PG&E Letter DCL-19-039

Response to NRC Request for Additional Information Regarding “License
Amendment Request 18-01, Request to Revise Emergency Plan Response
Organization Staffing and Augmentation”

**PG&E Response to NRC Request for Additional Information
Regarding "License Amendment Request 18-01, Request to Revise Emergency
Plan Response Organization Staffing and Augmentation"**

5.215.22 FIGURE 5-3, OSC ORGANIZATION

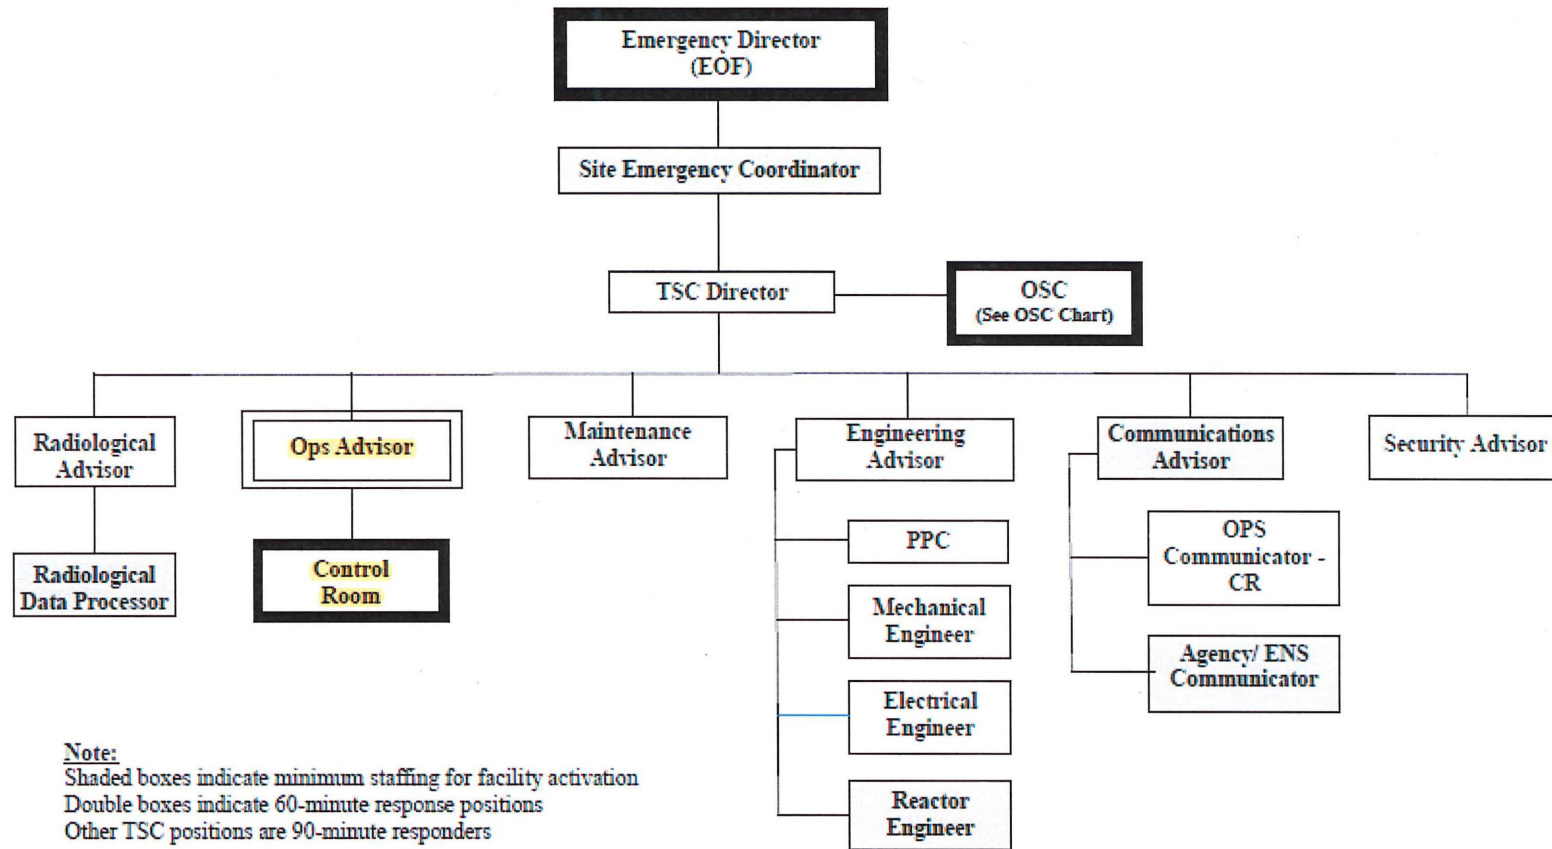
The proposed PG&E Figure 5-3, "OSC Organization," includes changes from the current DCPD Emergency Plan. Based on a review of the proposed Figure 5-3, it appears that DCPD proposes eliminate maintenance personnel while retaining their respective maintenance coordinators. However, the proposed Table 5-1, "DCPD on-Shift and Augmented ERO Minimum Staffing," includes maintenance personnel and does not specifically identify maintenance coordinators. The staff could not identify a discussion that supported this change. Additionally, no discussion relative to the responsibilities of the maintenance coordinators was apparent in the Evaluation of Proposed Changes.

- a. Please provide justification for combining maintenance personnel with their respective maintenance coordinators. This justification should explain how the maintenance coordinators can perform both the maintenance technician role and the maintenance supervisor role for maintenance and troubleshooting activities as effectively as a maintenance technician and a maintenance supervisor.*

- c. Please explain why the maintenance coordinators are not identified on the proposed Table 5-1, since they are identified as responders within 60 and 90 minutes on Figure 5-3.*

PG&E has reevaluated the proposed changes to Figure 5-3 for the Maintenance positions and agrees that separate identification of Maintenance Coordinator and Maintenance personnel positions is appropriate. Additionally, PG&E will maintain

the 60-minute response requirement for the Mechanical and Electrical Maintenance Coordinators as reflected in the proposed Table 5-1 of the DCP E-Plan. The response time for the Maintenance Coordinators also provides relief of the technical support function as described in RAI-6a with respect to planning for event mitigation actions and assumption of supervisory responsibilities to relieve the on-shift staff.

Table 5-1 and Figure 5-3 of the proposed change has been revised to reflect this change. The affected pages of the proposed DCP E-Plan are included in Attachment 1 (highlighted markup).

5-205.21 FIGURE 5-2, TSC ORGANIZATION

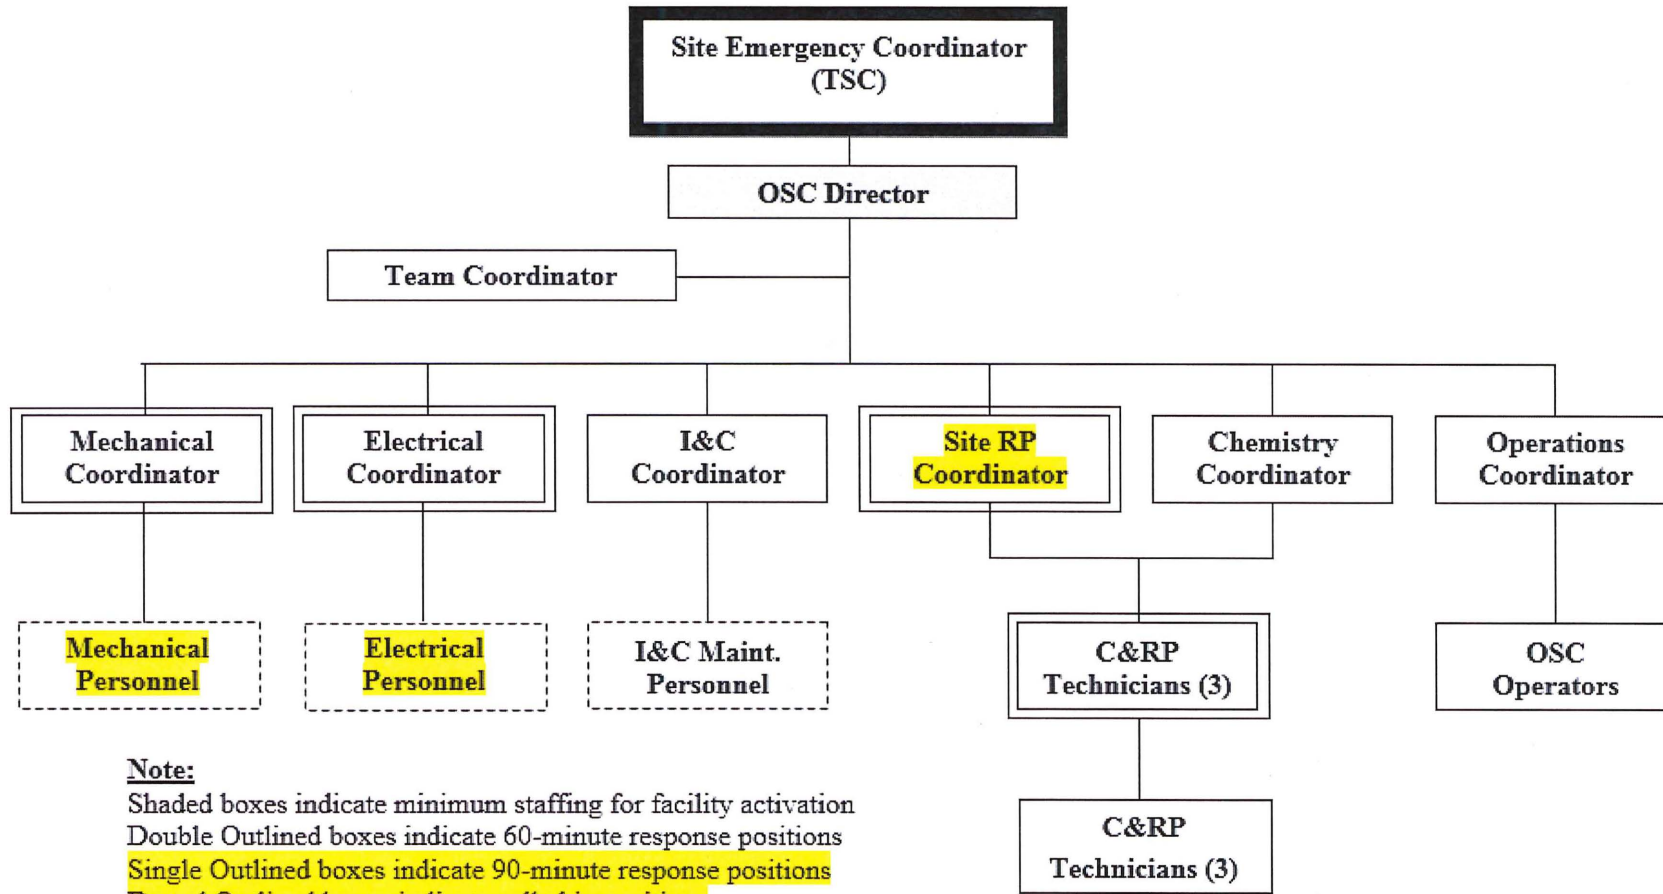
PG&E proposes to extend the augmentation timing of the Site Emergency Coordinator (SEC) at the Technical Support Center (TSC) and the Emergency Director (ED) at the Emergency Operations Facility (EOF) from 60-minute to 90 minutes responders. The justification provided is to have the Operations Advisor, who does not appear to be qualified as either a Shift Manager (SM) or an Emergency Director, report to the control room (CR) within 60 minutes from the declaration of an Alert or higher classification level, in lieu of the responding to the TSC. As such, the Operations Advisor does not appear to be relieving the SM of emergency plan functions.

Please provide specific justification as to how relocating the Operations Advisor from the TSC to the CR adequately augments (relieves) the Shift Manager position from providing oversight of the plant response to allow for performance of Emergency Coordinator responsibilities for emergency plan implementation for the additional timing requested, consistent with the guidance in RIS 2016-10 and the revised Table B-1, which serve as an acceptable means of meeting planning standard 10 CFR 50.47(b)(2).

Additionally, please provide a justification that supports removing the Operations Advisor from the TSC. This justification should include a discussion on who will assume the tasks are currently being performed by the Operations Advisor in the TSC.

The proposed change provides for response within 60 minutes by the TSC Operations Advisor to the CR to relieve the SM of the responsibility for oversight

The proposed change maintains the Operations Advisor as a position in the TSC.

The purpose behind maintaining the 60-minute response time for the Operations Advisor is to ensure that resources are made available to relieve CR event response activities in the same timeframe as required in the current PG&E E-Plan. The proposed change provides for initial response by the Operations

Advisor to the CR as noted in RAI-1a, and provides for transition of this position to the TSC upon staffing of that facility.

Based on this RAI, PG&E has revised Section 5.6.11 of the E-Plan to provide additional clarification regarding Operations Advisor responsibilities and reporting locations.
